ADMINISTRATIVE AMENDMENT (PD) ADD2015-00070

**ADMINISTRATIVE AMENDMENT
LEE COUNTY, FLORIDA**

FINAL PLAN APPROVAL
MIROMAR LAKES
RECREATIONAL LAKE
SHORELINE STABILILIATION

MEMORANDUM
FROM THE
DEPARTMENT OF
COMMUNITY DEVELOPMENT
DEVELOPMENT SERVICES DIVISION

MASTER STABILIZATION PLAN

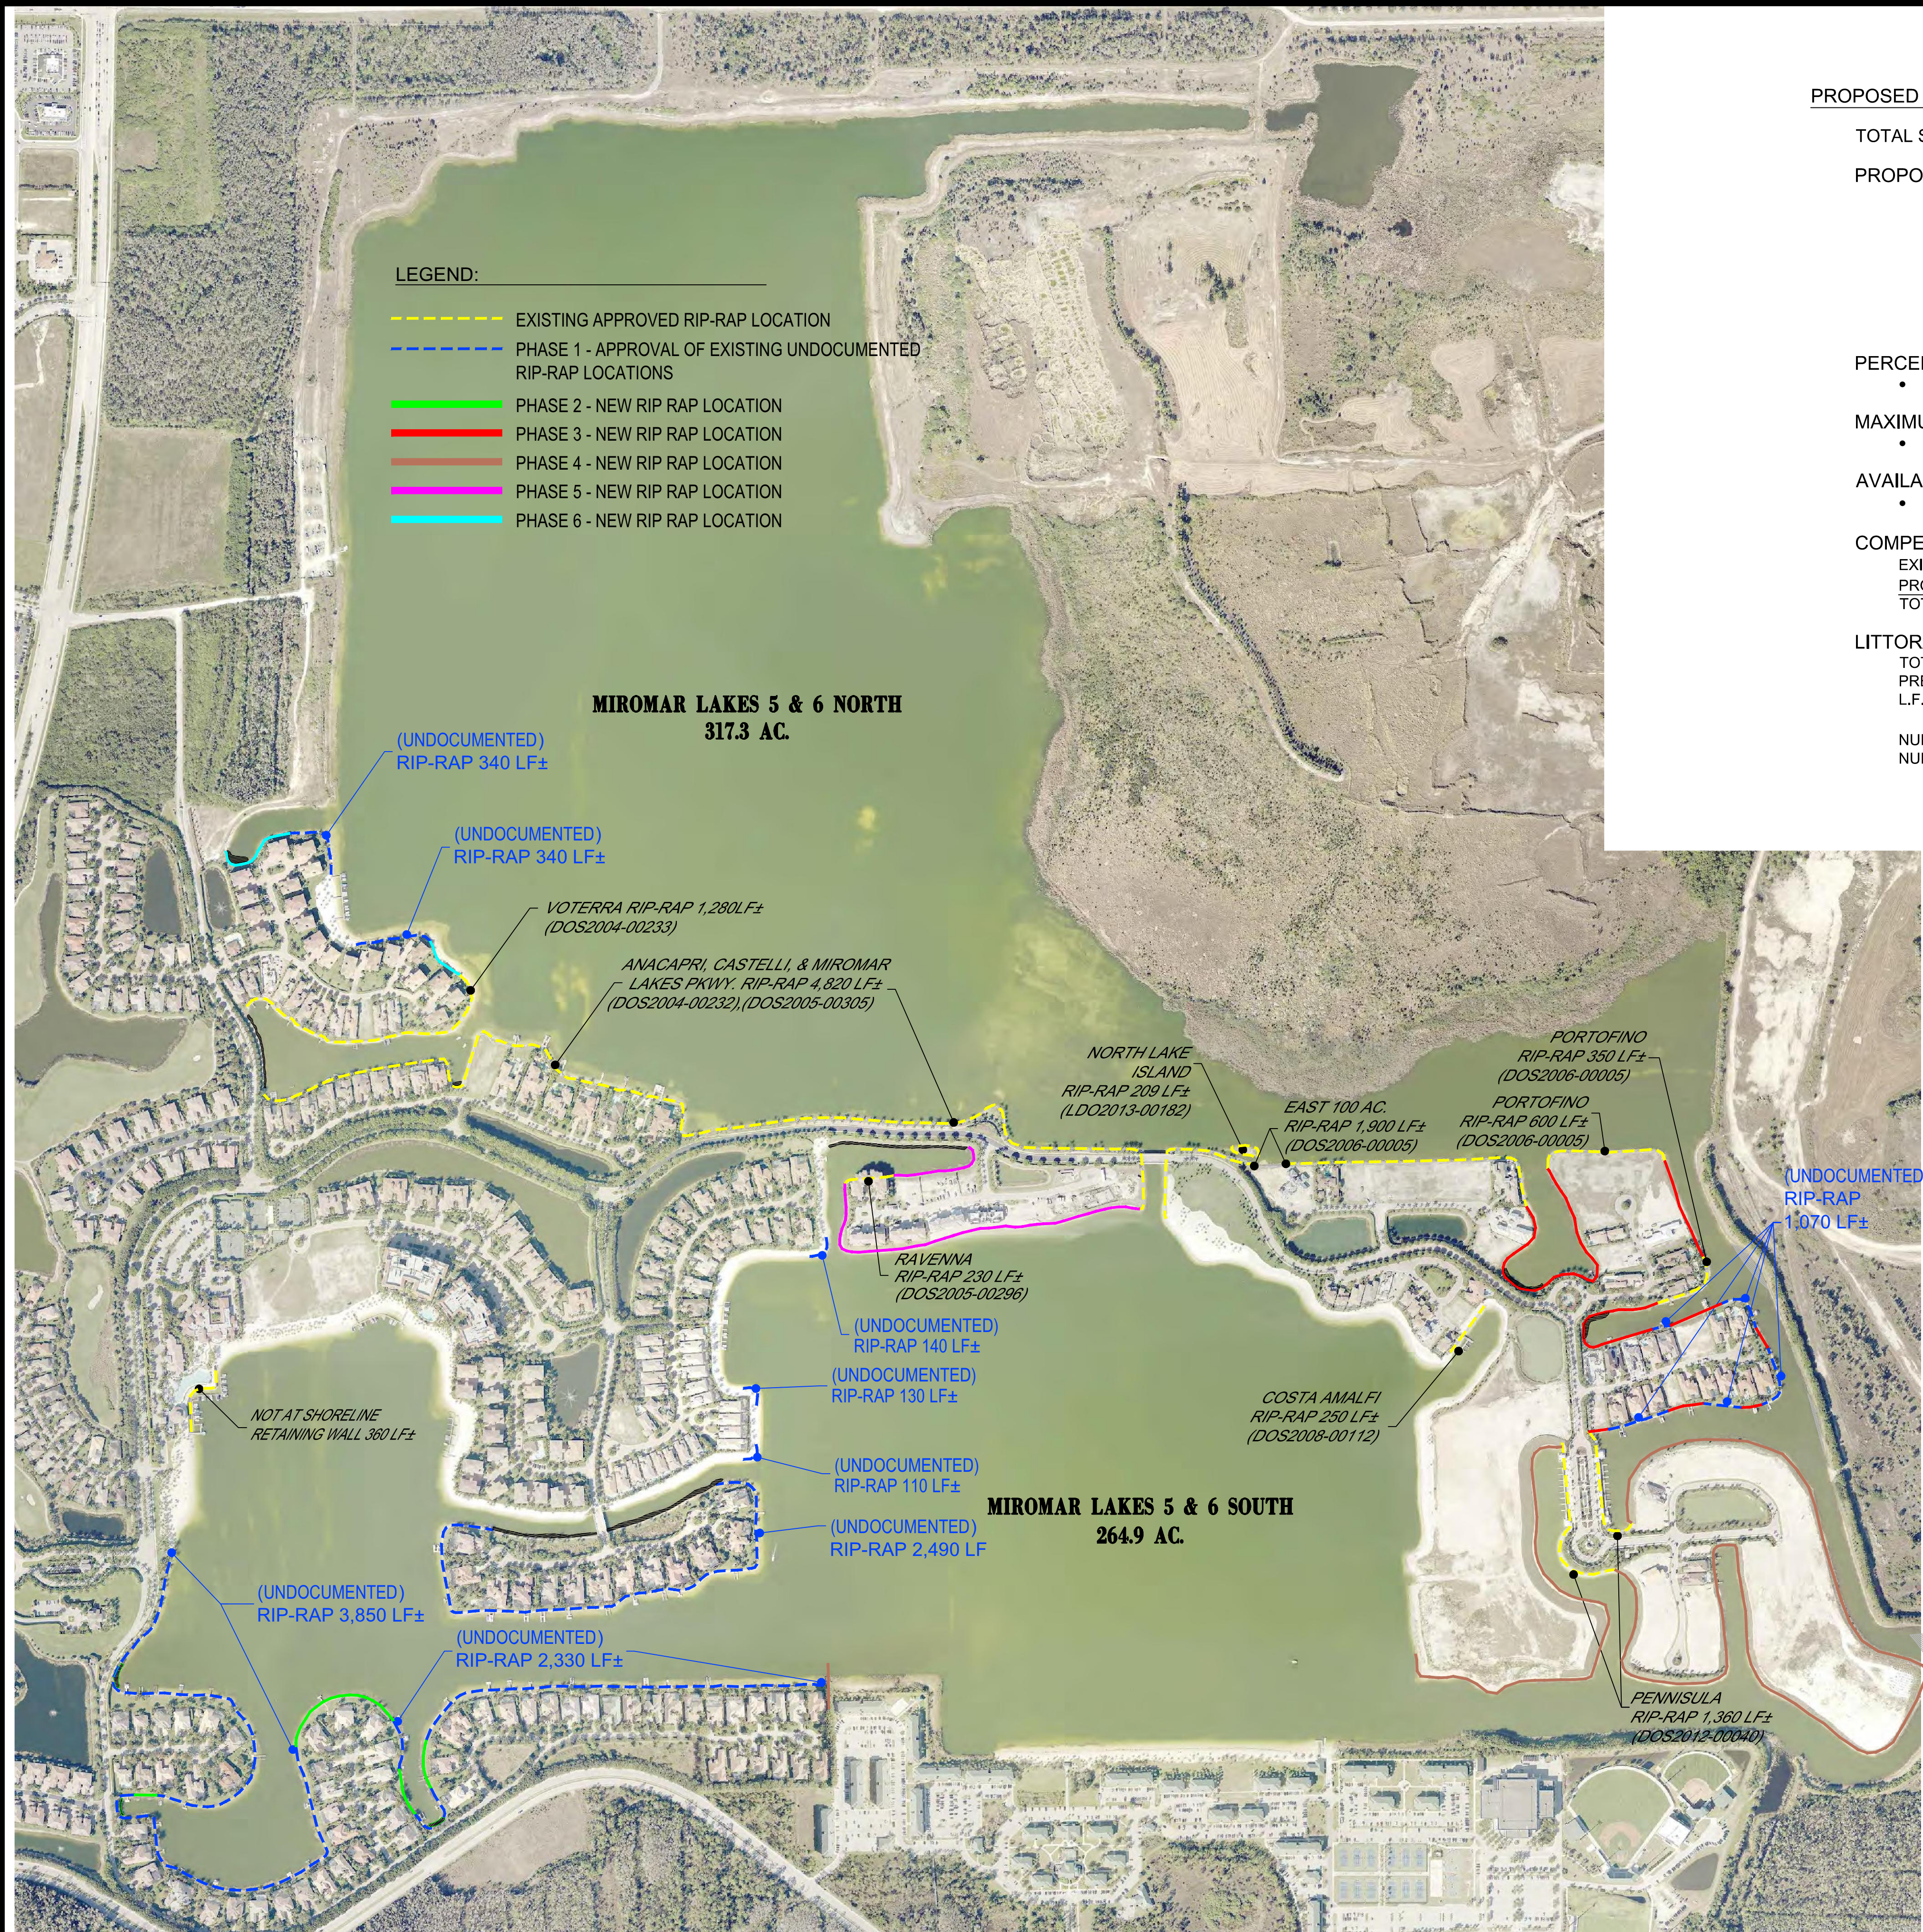
- 1) REQUESTED DEVIATION: from Section 10-418.(3) which limits the use of rip-rap and other hardened shoreline treatment to 20% of an individual lake shoreline; to allow up to 65% of the shoreline on the developed portions of north and south recreational lakes within the Miromar Lakes community at the time of this application.

- 2) REQUESTED DEVIATION: from Section 10-481.(3), which prohibits the use of rip rap adjacent to single family residential uses; to allow the use of rip rap adjacent to single family uses.

- 3) REQUESTED DEVIATION: from Section 10-329(d)(4) which requires lake banks to be sloped at a 6:1 ratio from the top of bank to a water depth of two feet below the dry season water table; to allow for a minimum ratio of 4:1 where turf reinforcement mat is proposed, and a minimum ratio of 2:1 where rip rap shoreline is proposed.

- 4) REQUESTED DEVIATION: from Section 26-75(d).2, which requires the use of filter fabric when rip rap shoreline stabilization is used; to allow the existing rip rap designated in Phase 1 to remain without use filter fabric until such time as the existing rip rap needs to be repaired or replaced.

1. **The Development must be in compliance with the Miromar Lakes Recreational Lake Shoreline Stabilization plans per Attachment "A".**
2. **New Development Orders will require the preparation of a Lake Maintenance Plan addressing the components of LDC Sec. 10-329(d)(5)(a-e).**
